Commonwealth Edison Company  
Byron/Braidwood Units 1 and 2  
Relaxation of MSSV Setpoint Tolerance to +/-3% - Revised SECL

Enclosed please find Revision 1 to safety evaluation SECL 90-469, previously transmitted via Reference 1. The revised safety evaluation clarifies the section of the ASME code associated with the main steam safety valves.

WESTINGHOUSE NUCLEAR SAFETY  
SAFETY EVALUATION CHECK LIST

APPENDIX B  
UFSAR MARKUPS

FIGURE 15.2-6

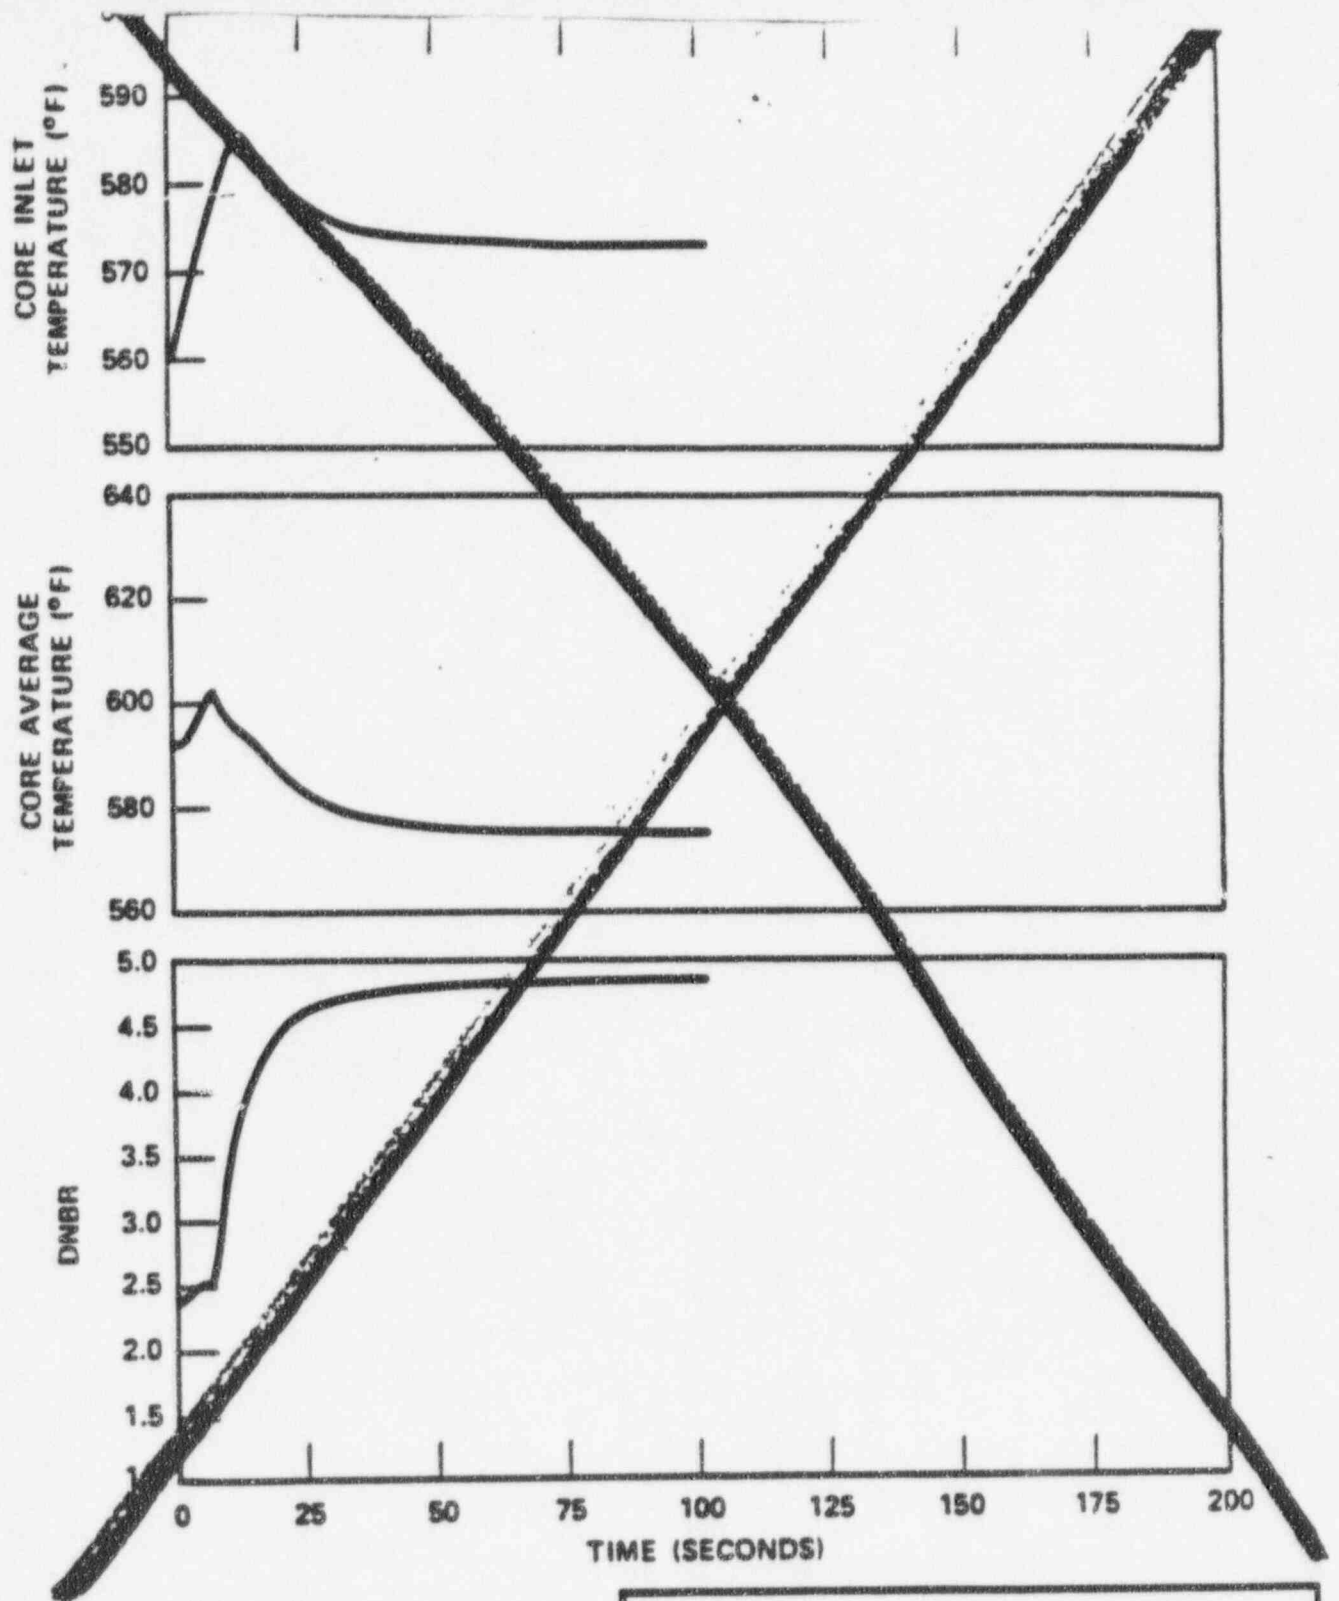
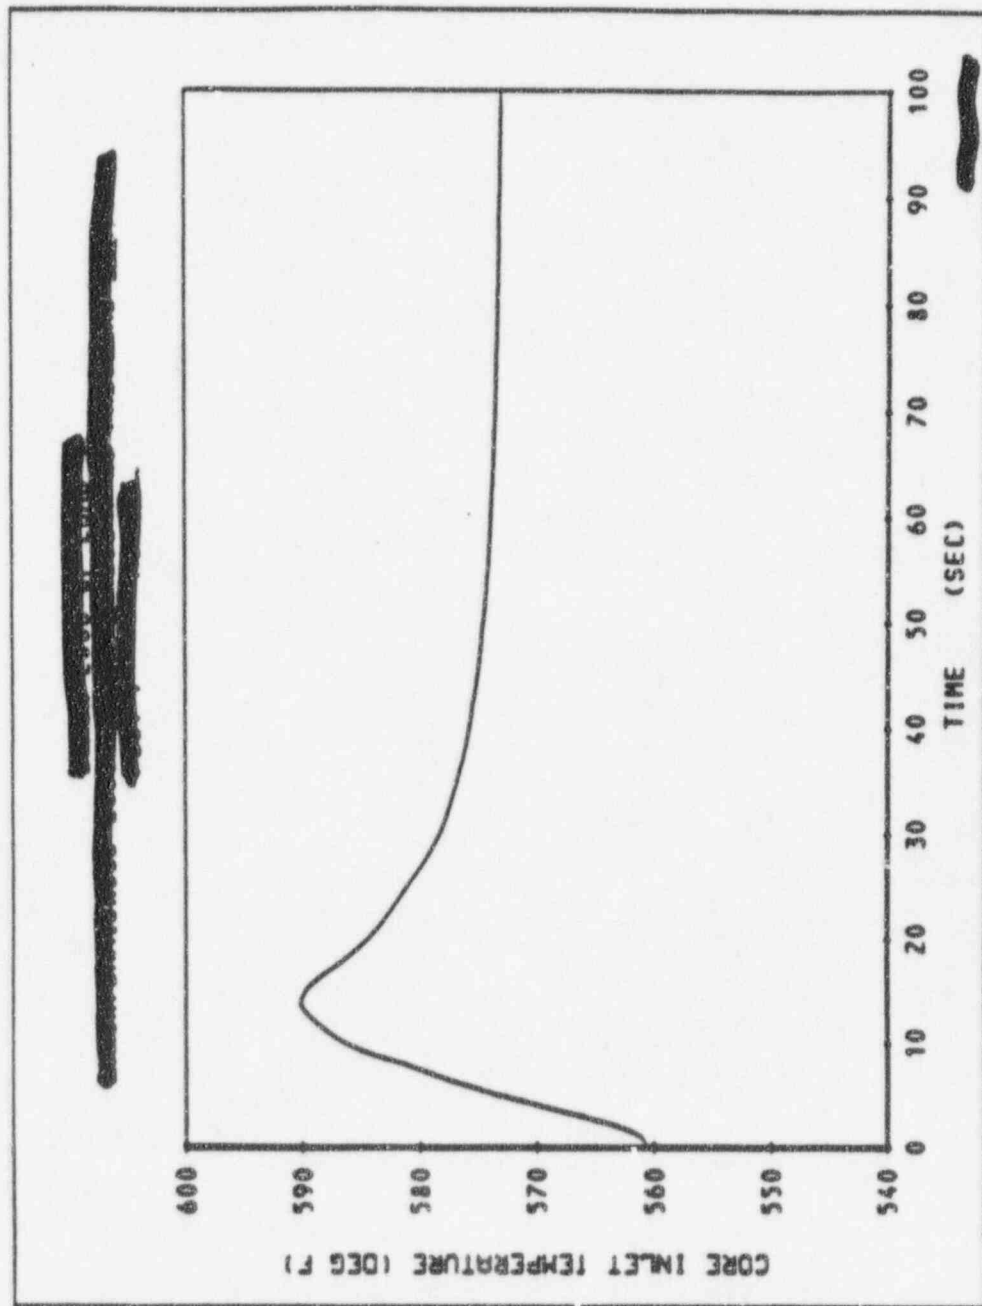
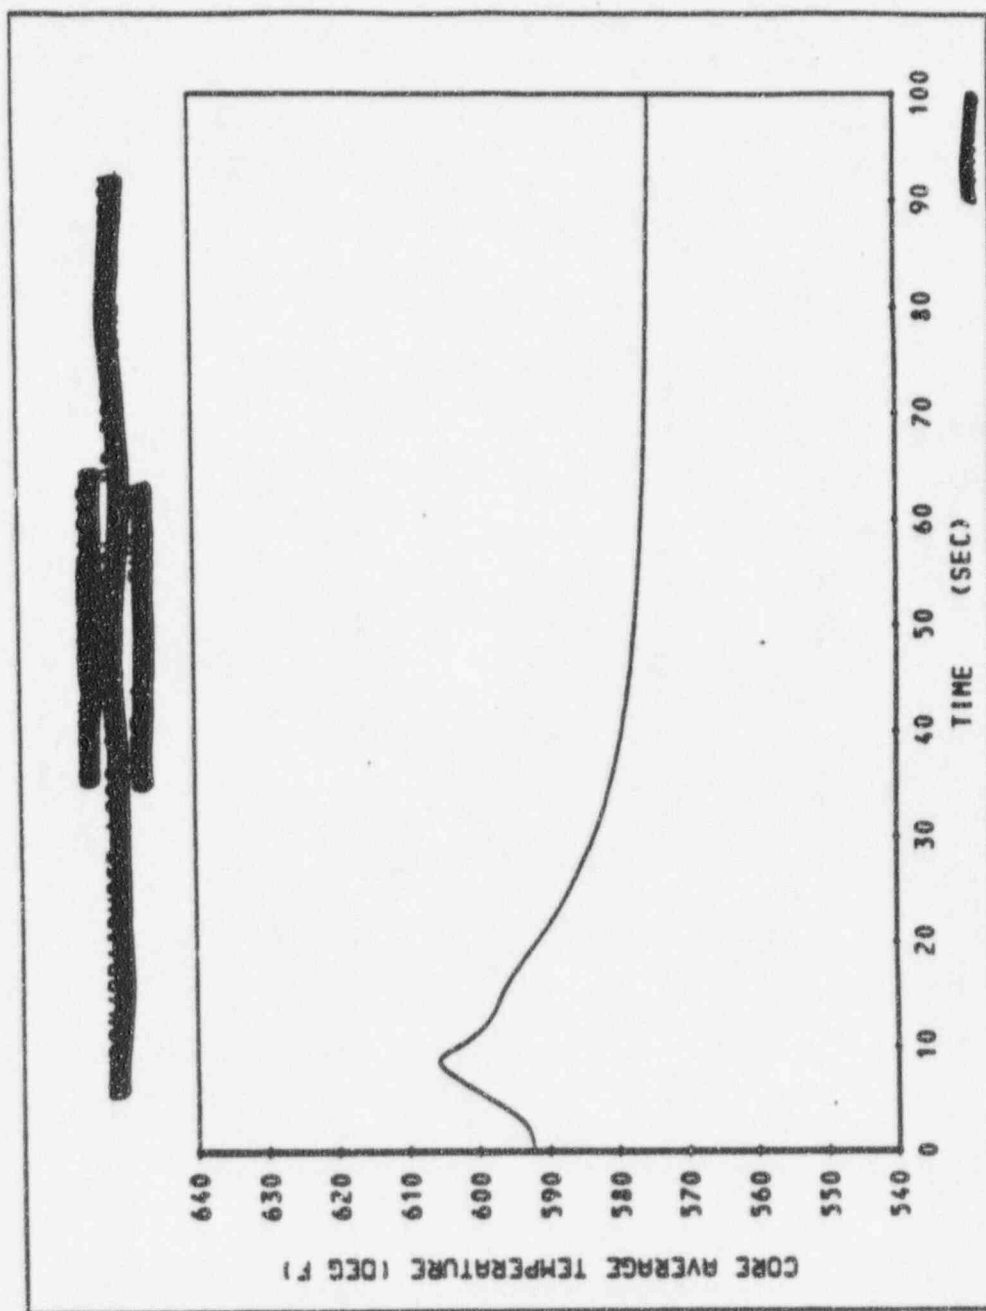
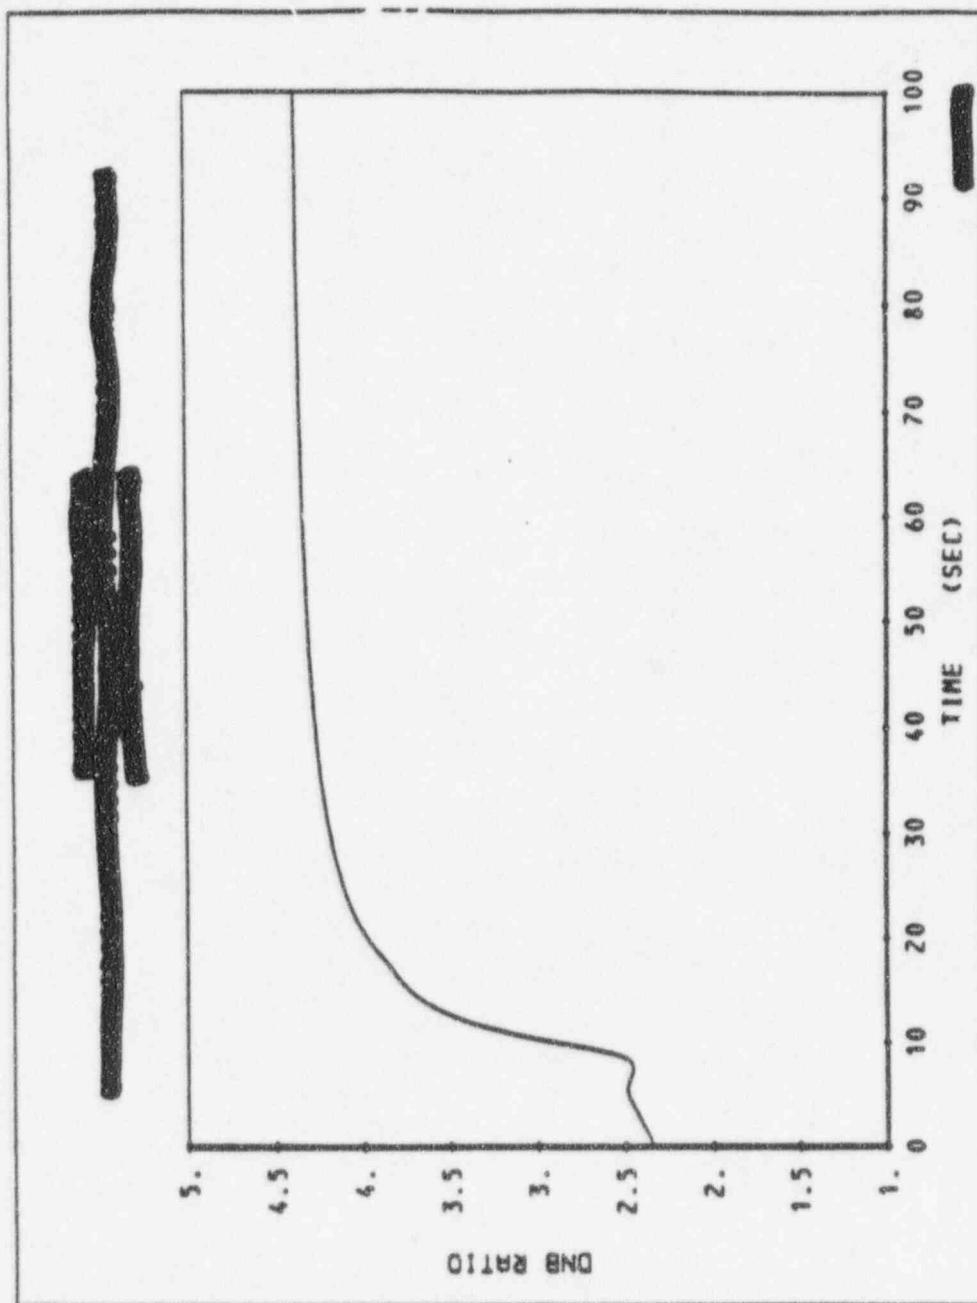
REPLACE with  
the following  
Figures
